OPEN SPACE COMMUNITY REVIEWS AND APPROVALS

OSC 17-02

To consider approval of an R-20 Open Space Community Overlay application for W&H Investments, LLC regarding Application OSC 17-02 filed December 6, 2016, for property located on the west side of Mount Calvary Road, north of Dallas Highway in Land Lot 328 of the 20th District and Land Lot 30 of the 19th District, Cobb County, Georgia.

OSC-17-02
(Plan date 12-19-16)

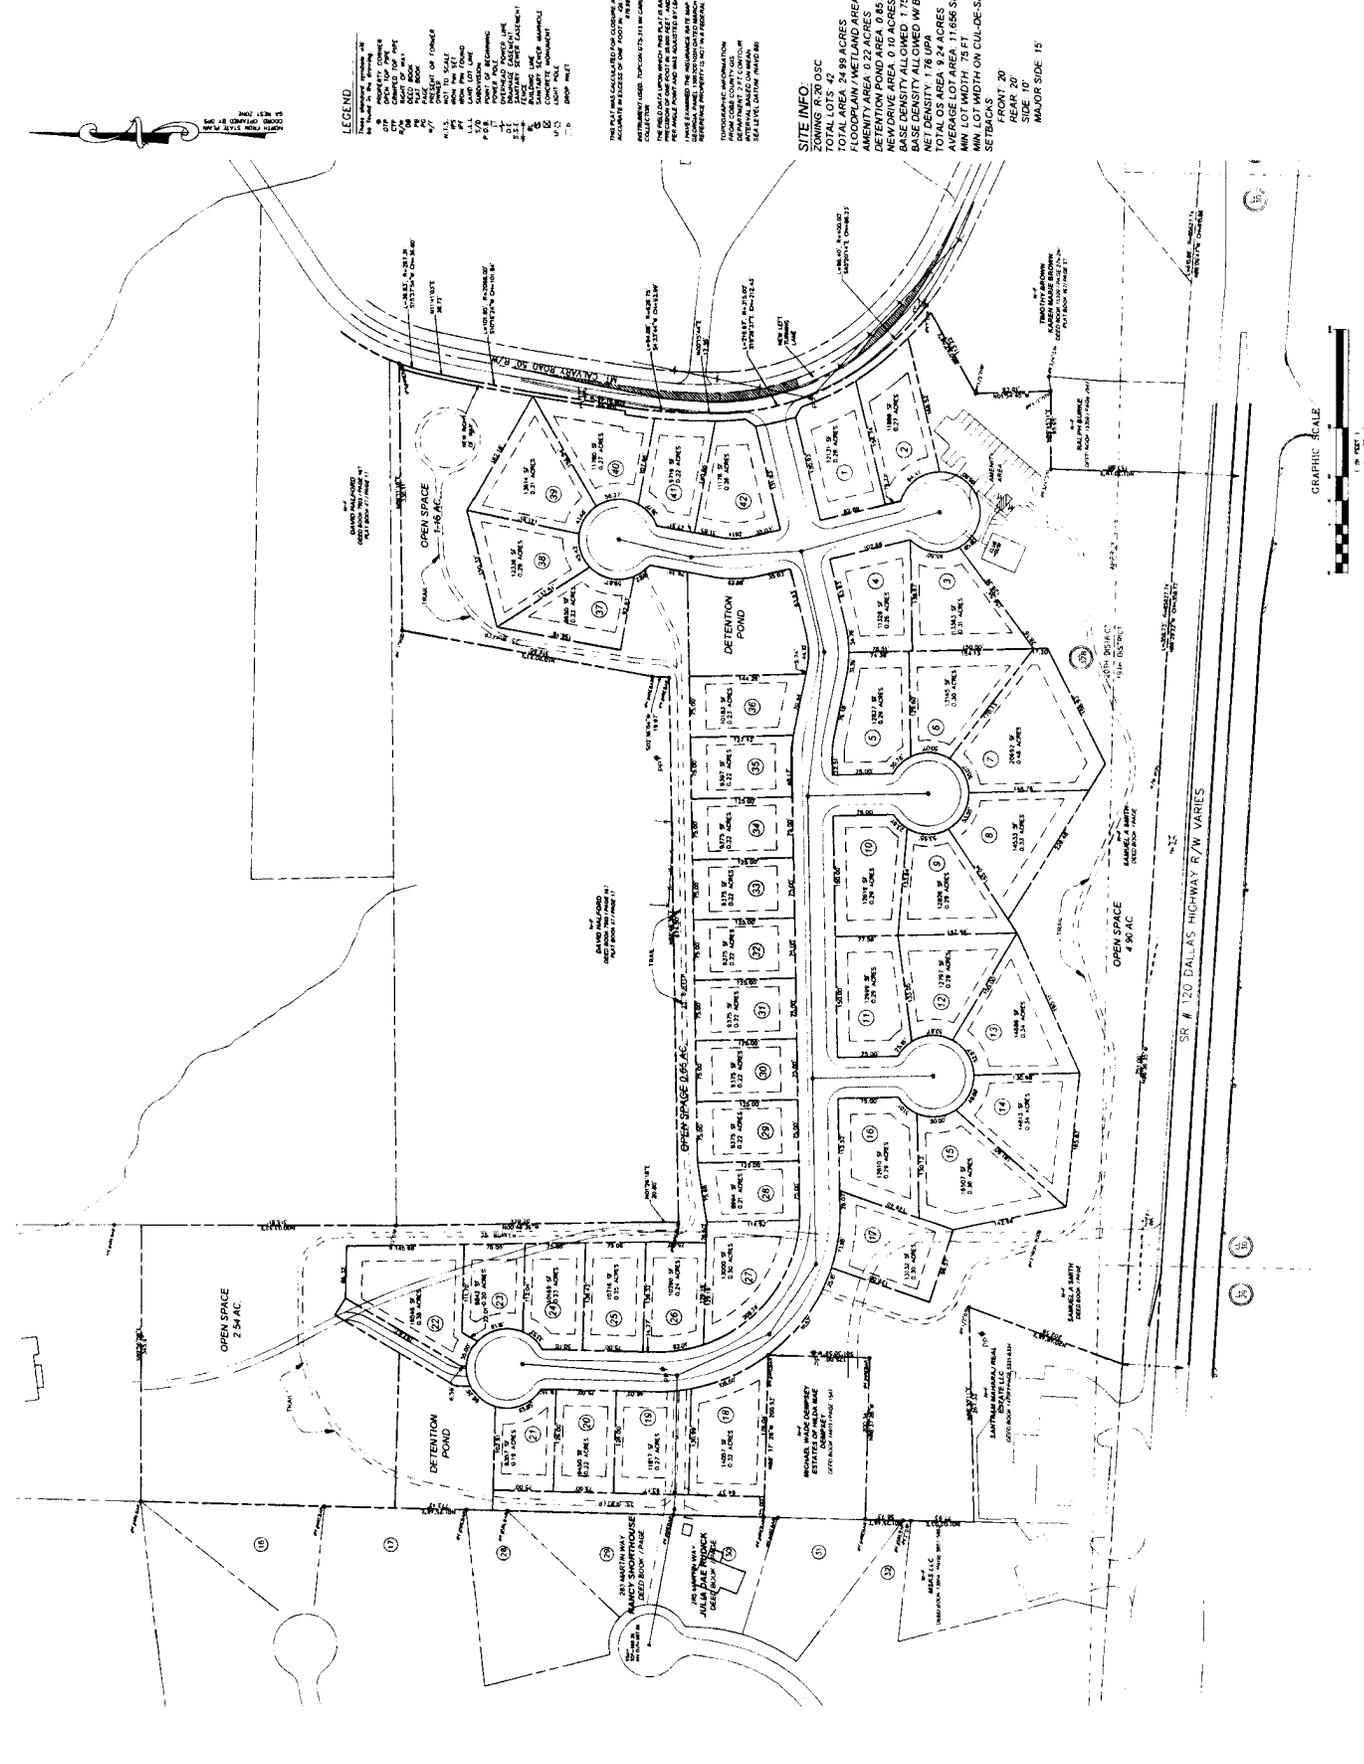
1. Overall residential development shall be compatible with neighboring residential uses. In areas where adjoining residential uses are larger than those proposed, the plan should incorporate larger lots adjacent to those existing residential uses with smaller lots designed to the interior. Lots 28-36 & 19-21 are considerably smaller than neighboring residential uses. Applicant should work toward larger lot sizes for those exterior lots mentioned previously. As a way to compensate, Lots 1-17, which are more toward the interior of the project and adjacent to open space and Dallas Highway, could be modified to offset the differences.

2. Proposed trail network within open space will need to be constructed of porous materials and noted on site plan submitted for LDP.
3. Driveway located within the open space toward the northwest corner of project will need to be calculated out of open space if it is constructed of impervious material.

- A. It is Staff's opinion that the applicant's use of the OSC overlay will permit a use that is suitable in view of the use of adjacent and nearby properties as long as appropriate measures are taking, which are highlighted within staffs comments. The compatibility of lot sizes are not suitable compared to lot sizes adjacent to proposed development. Lots for the proposed OSC overlay are considerably less than adjacent residential lots. Adjustments to the site plan may be considered.
